Access Compliance Report

Public Rights-of-Way

(Curb Ramps)

Intersection ID: 46821	Main Street: RED_PINE_CT	Cross Street: AZALEA_HILLS_DR	Location:	N
ADA ID: 6CEFD7E454C7	Ramp Type: PerpDiag	Initial Pass/Fail: Fail	Overall Compliance: No	Severity Score: 8.75

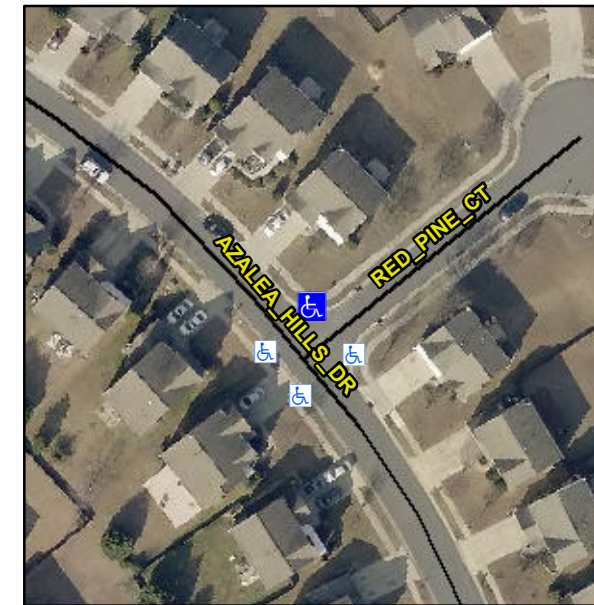
Compliance	Description	Data	Compliance	Description	Data
N/A	Ramp Length (in)	47.0	Yes	Ramp Slope (%)	7.4
No	Ramp Width (in)	43.2	Yes	Ramp XSlope (%)	0.3
N/A	Flare Type LT	N/A	N/A	Flare Type RT	N/A
N/A	Flare Slope LT (%)	N/A	N/A	Flare Slope RT (%)	N/A
N/A	Flare Traversable LT?	N/A	N/A	Flare Traversable RT?	N/A
N/A	Landing Length (in)	N/A	N/A	DWS Provided?	N/A
N/A	Landing Width (in)	N/A	N/A	DWS Contrast?	N/A
N/A	Landing Slope (%)	N/A	N/A	DWS Length (in)	N/A
N/A	Landing X Slope (%)	N/A	N/A	DWS Full Width?	N/A
N/A	Landing Curb? (Y/N)	N/A	N/A	DWS Offset (in)	N/A
N/A	Shared Landing?	N/A			
N/A	Gutter Ponding?	N/A	N/A	Gutter Slope (%)	N/A
N/A	Gutter Lip Ht (in)	N/A	N/A	Gutter X Slope (%)	N/A
N/A	Painted X Walk1?	No	N/A	Painted X Walk2?	No
	X Walk 1 Direction	To SW		X Walk 2 Direction	To SE
N/A	X Walk 1 Width (in)	N/A	N/A	X Walk 2 Width (in)	N/A
	X Walk 1 Slope (%)	0.1		X Walk 2 Slope (%)	0.5
	X Walk 1 X Slope (%)	0.0		X Walk 2 X Slope (%)	0.7

Remove & Replace Curb Ramp With Two New Directional Ramps or Equivalent.
